TECHNICAL ADVISORY COMMITTEE REPORT & RESPONSES

FILE NUMBER: 16-DP-84

SUBJECT: Site Plan review for a 21 unit residential development (Cielo Azul at Hollywood).

GROUND FLOOR PLAN
SCALE: 1/8" = 1'-0"

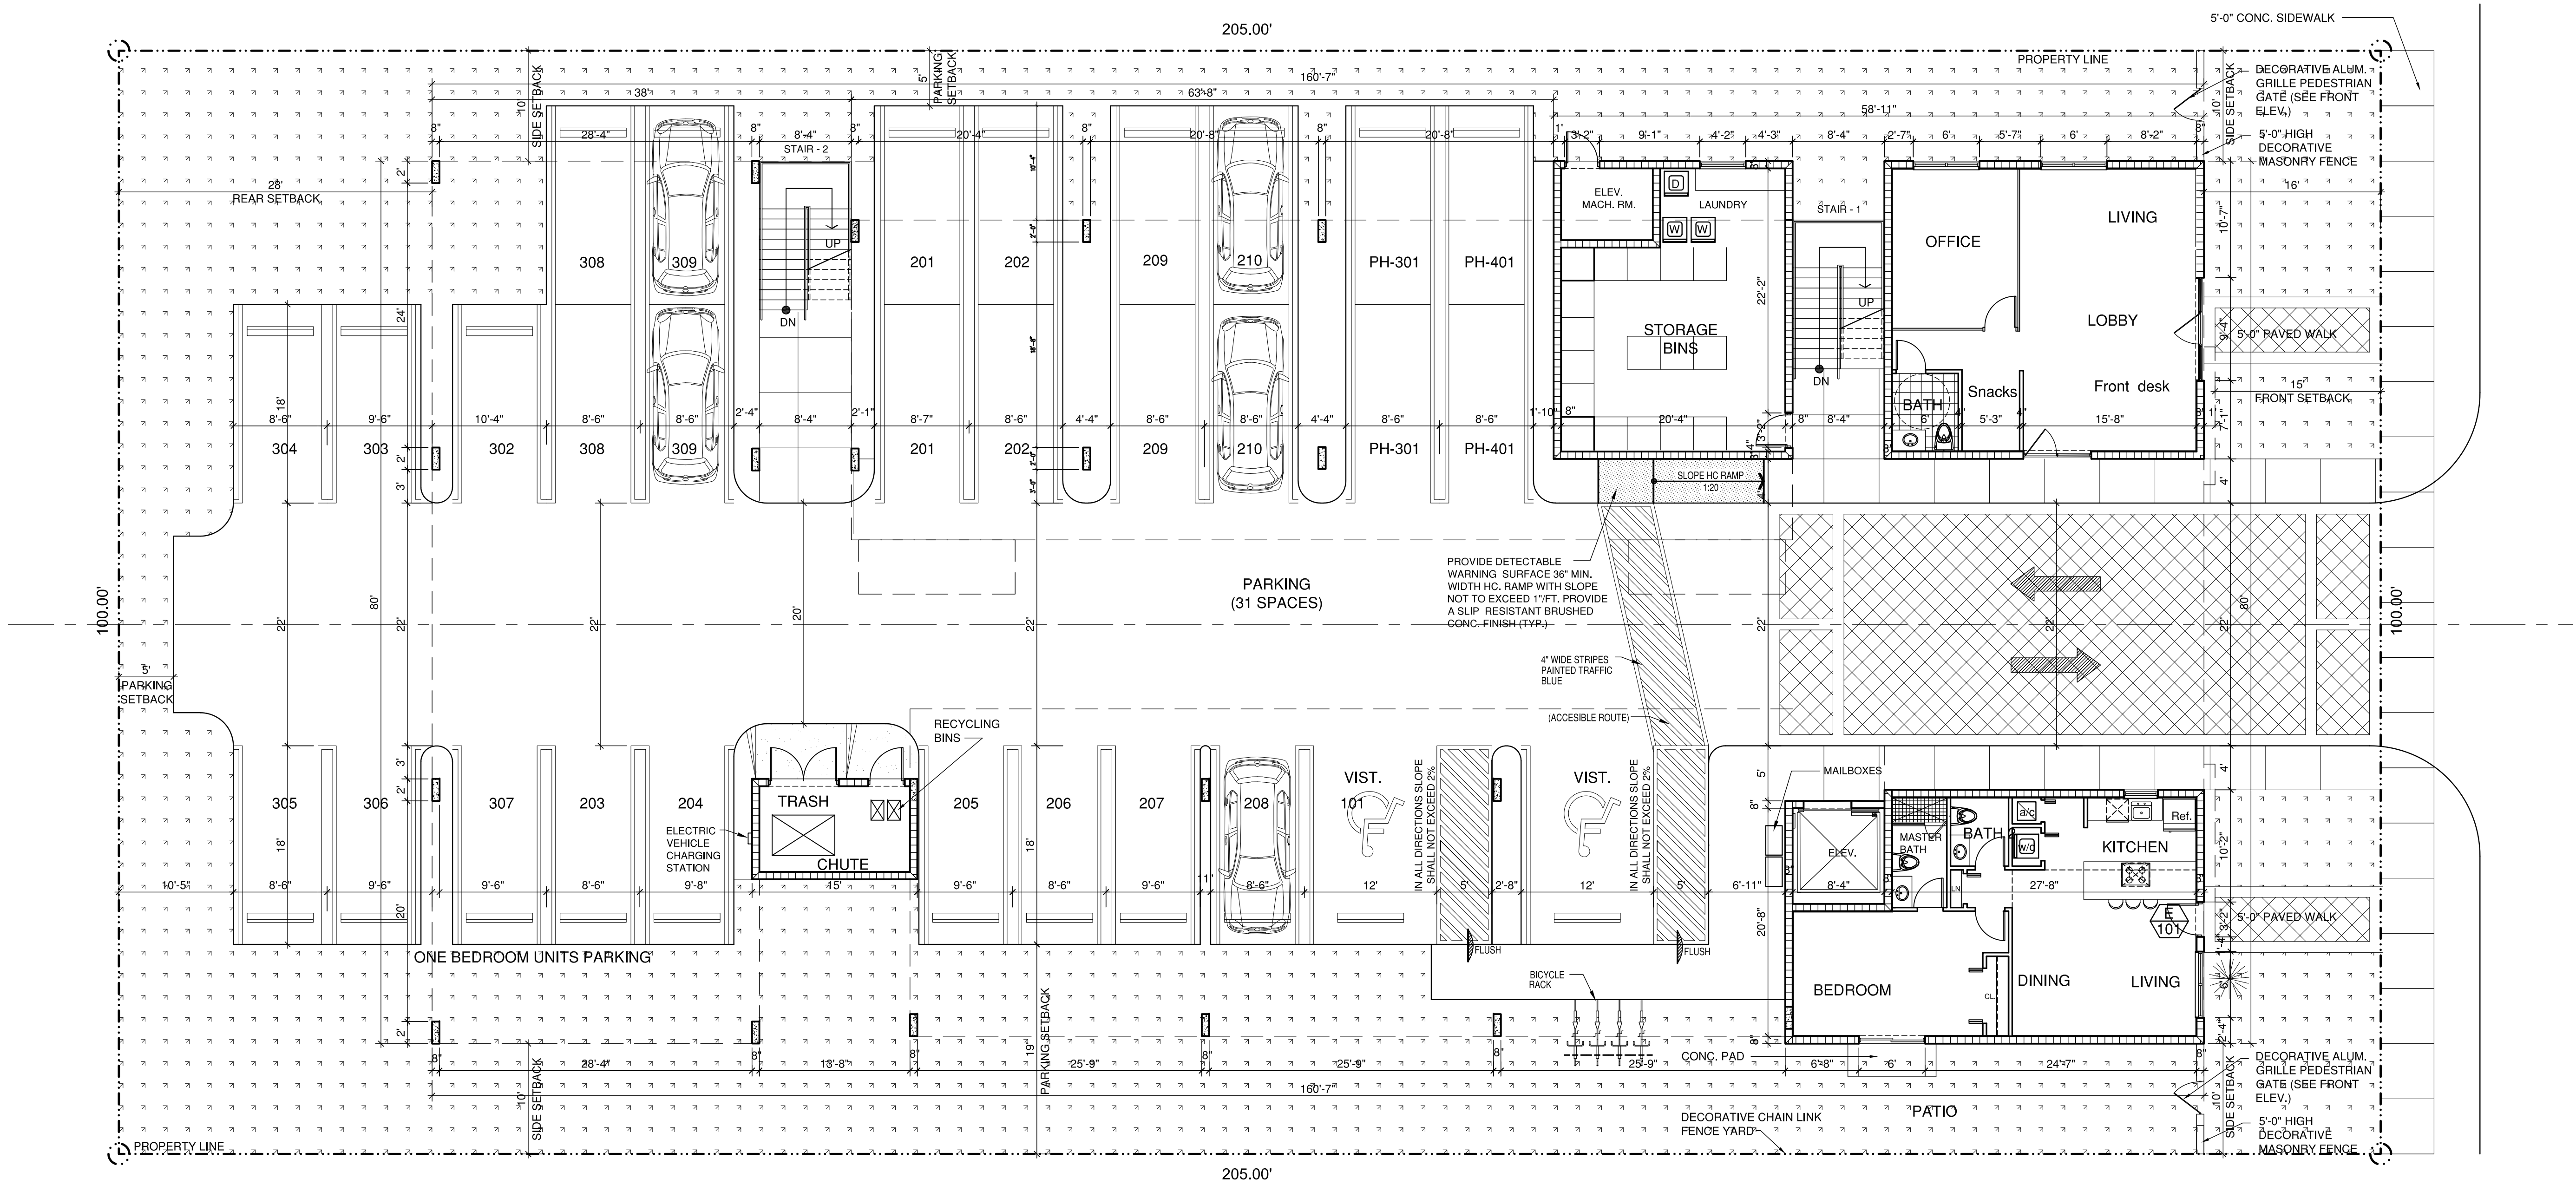
6. The "breeze way" on all floors is a corridor and all openings, doors and windows, must be protected with a Fire Rating of 30 minutes. FBC Table 1018.1

a. They are protected with a fire rating of 30 minutes

NOTE:
DOORS AND WINDOWS, MUST BE PROTECTED WITH A FIRE RATING OF 30 MINUTES, AS PER FBC TABLE 1018.1

SECOND FLOOR PLAN

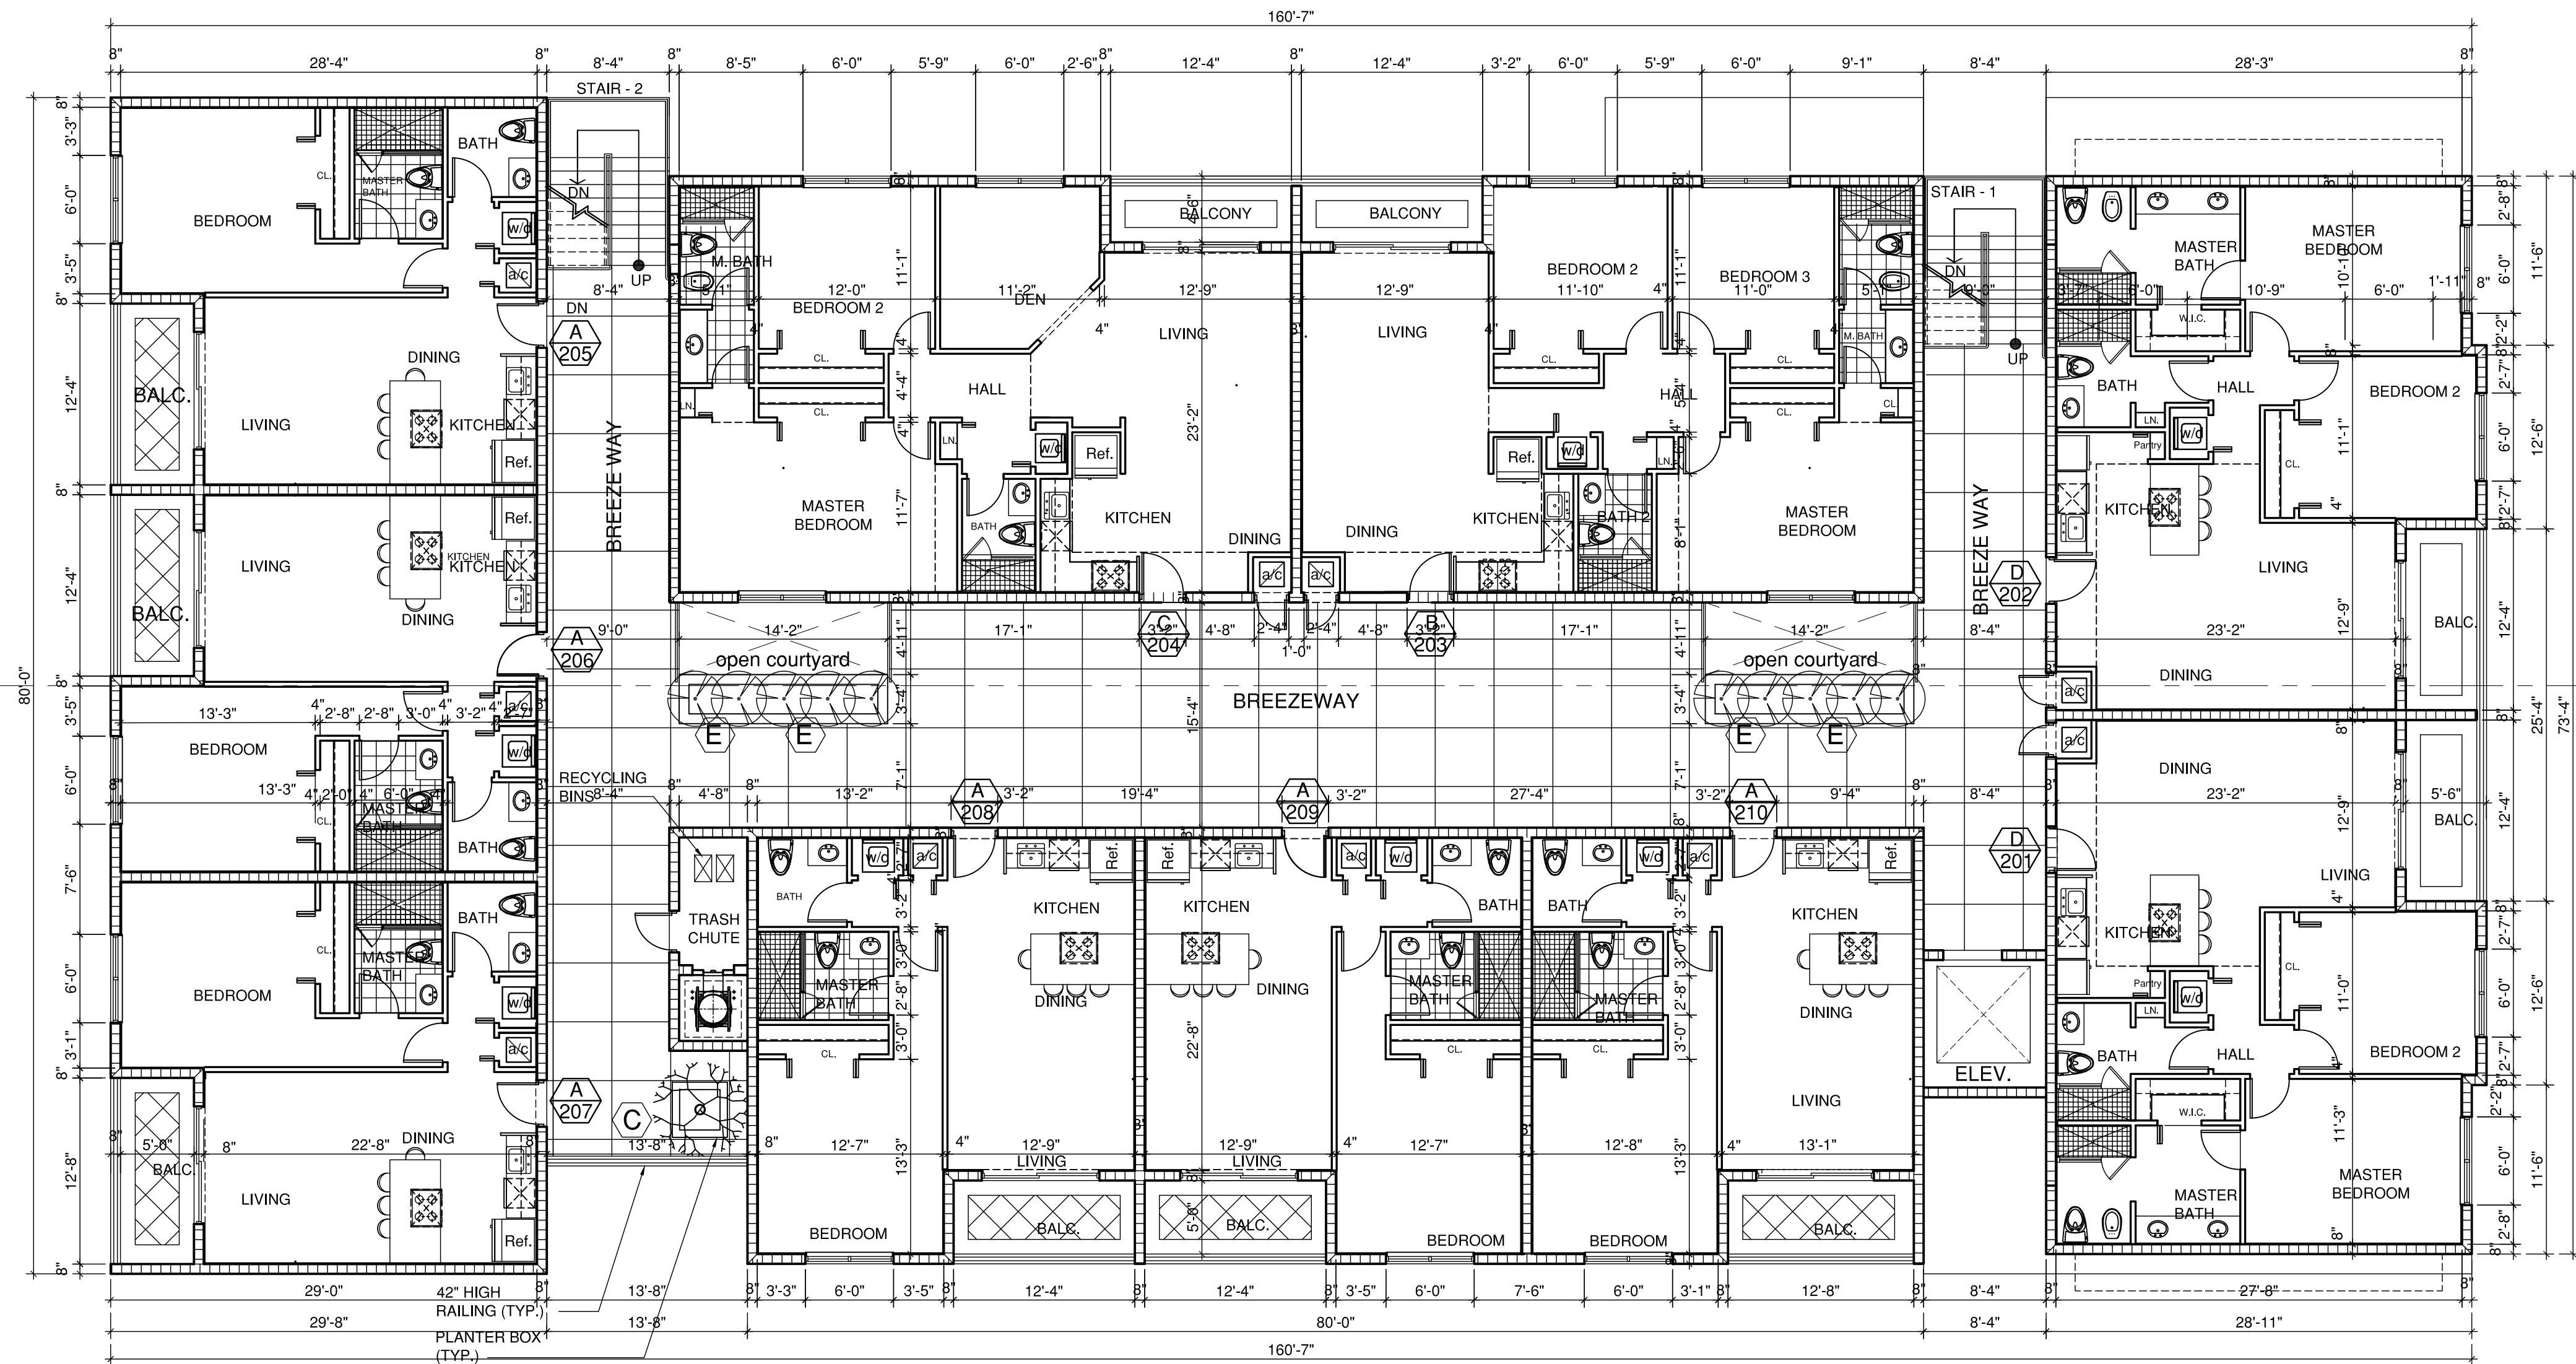
2. Sheet SP-1 – It appears that 8 units have W/D. I question whether the common laundry facilities are adequate for the remaining 13 units?

a. It was corrected on the new set of plan. All units have W/D see SP-1, A-2 and A-3

THIRD FLOOR PLAN

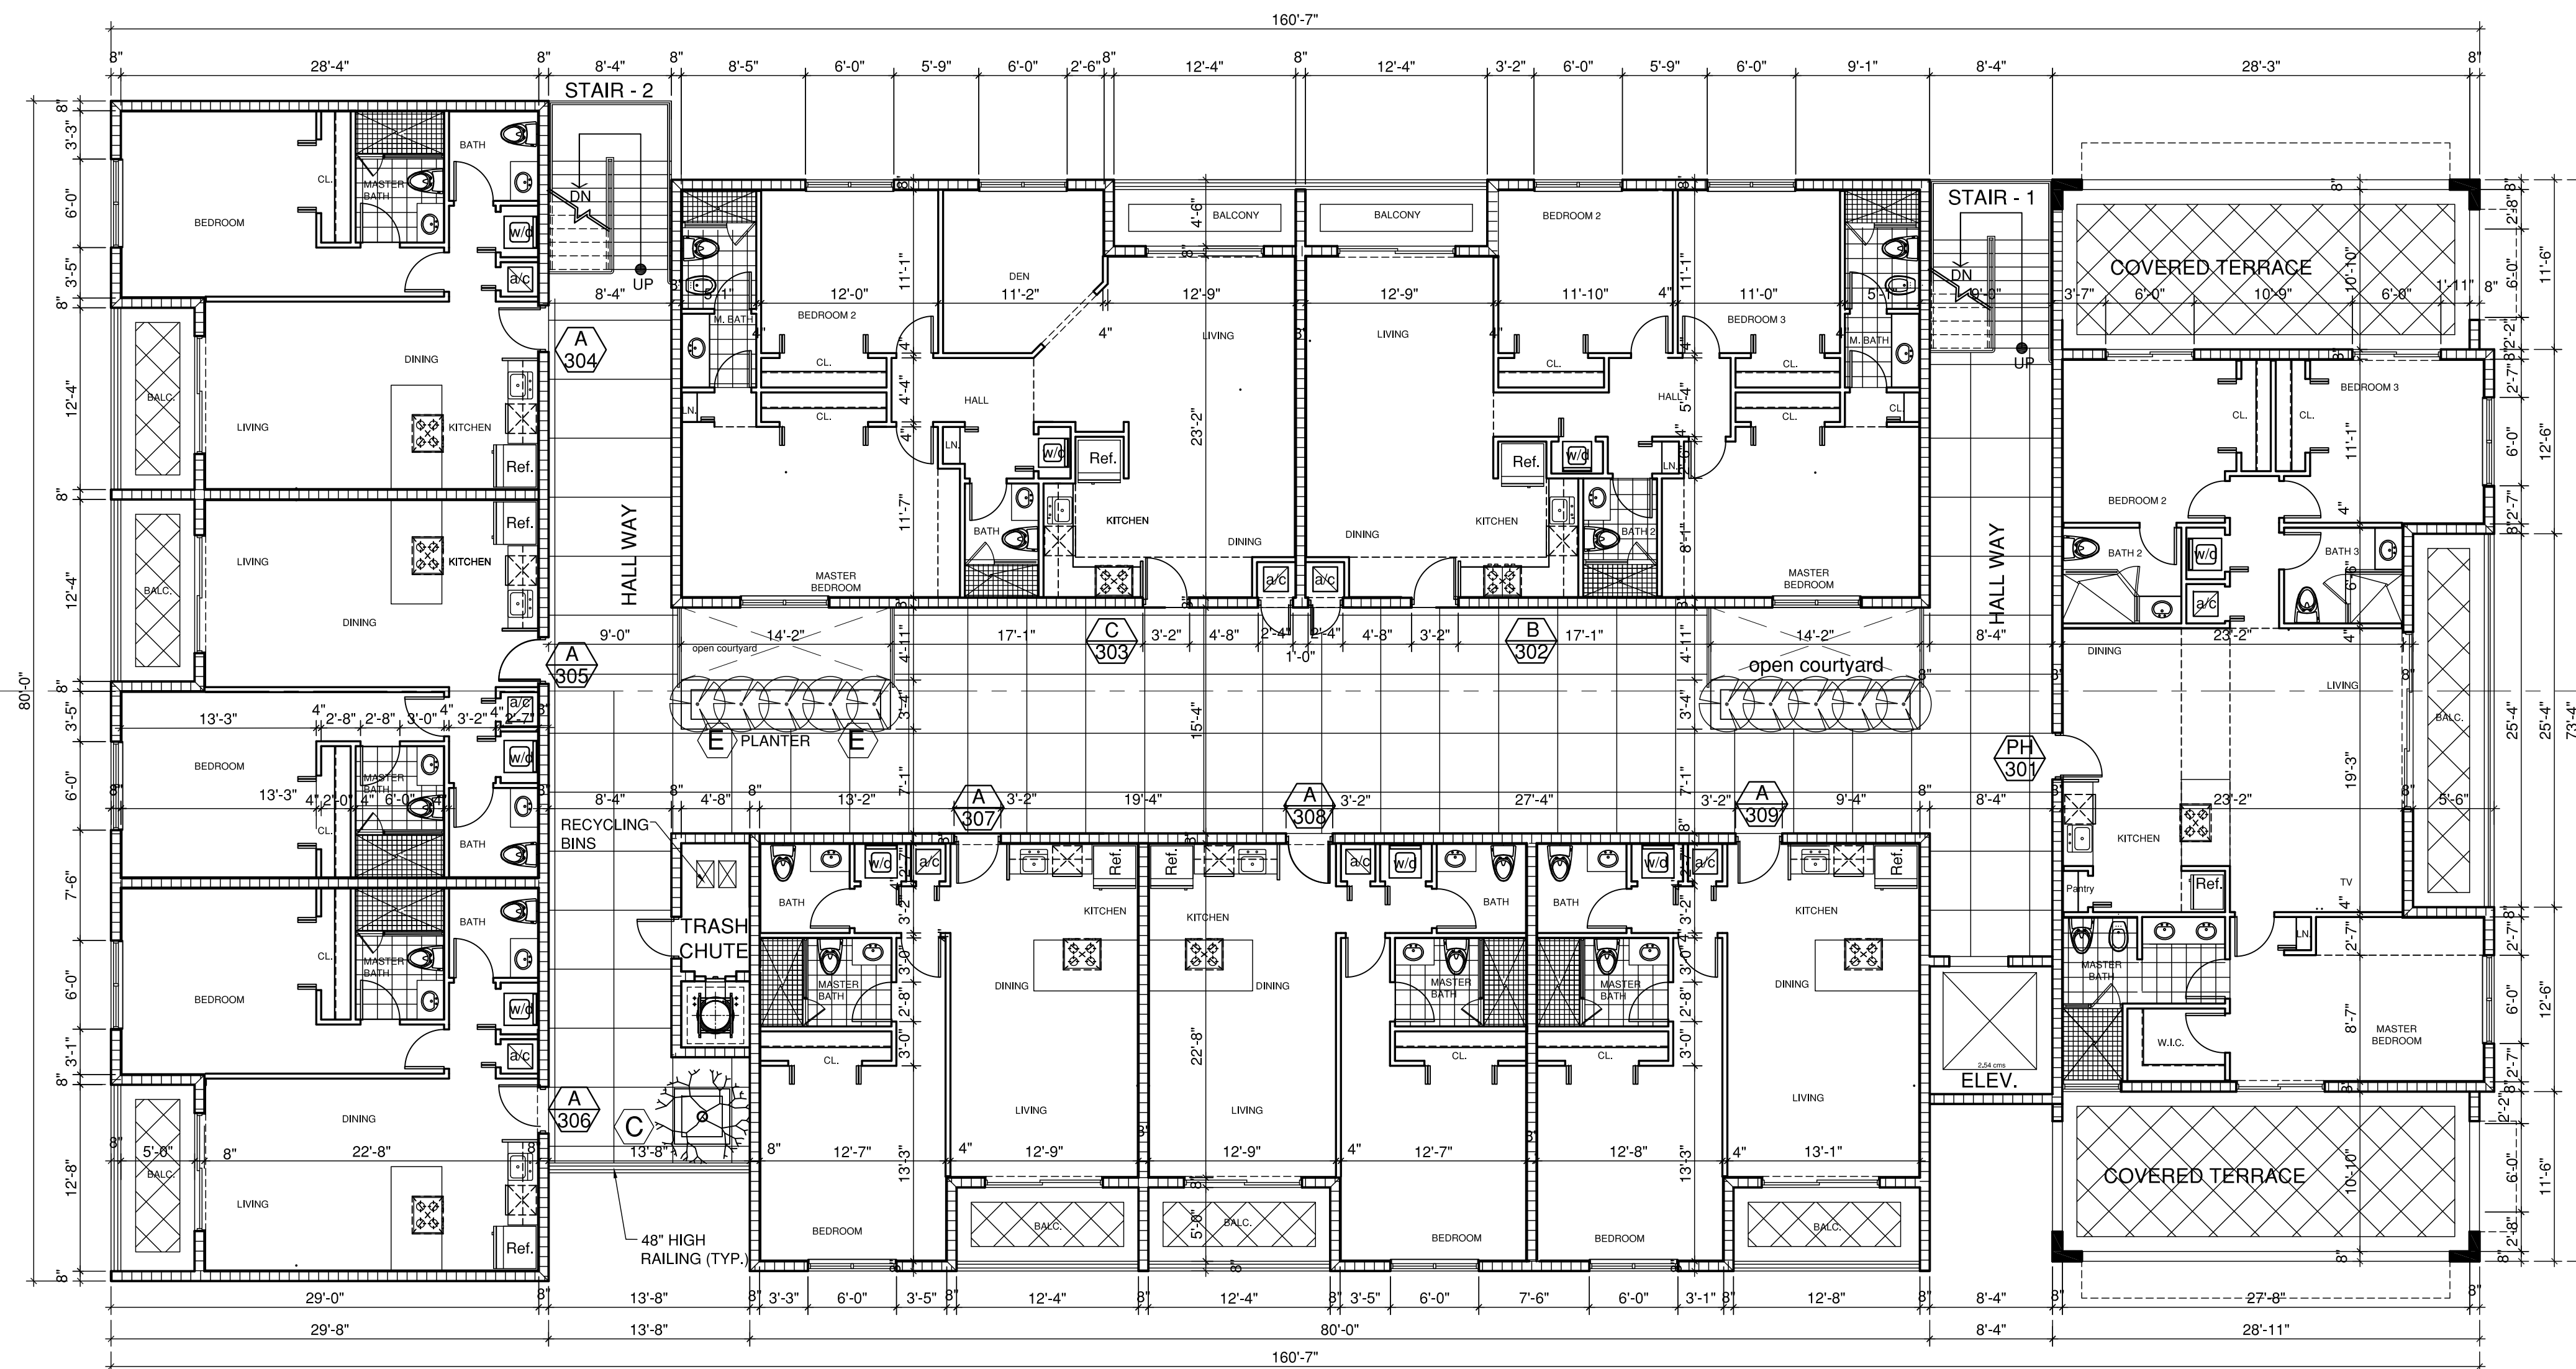
4. Show handicap access to the sun deck.

6. Sheet A-3 – What is the rooftop structure?

7. Sheet A-3 – There's no trash chute on 4th floor. How will PH-401 dispose of trash?

a. We placed a lift to have a handicap access to the sundeck see A-3

a. Is a decorative Gazebo and ornamental trellis

a. There is a chute on the 4th floor on the new set of plans see A-3
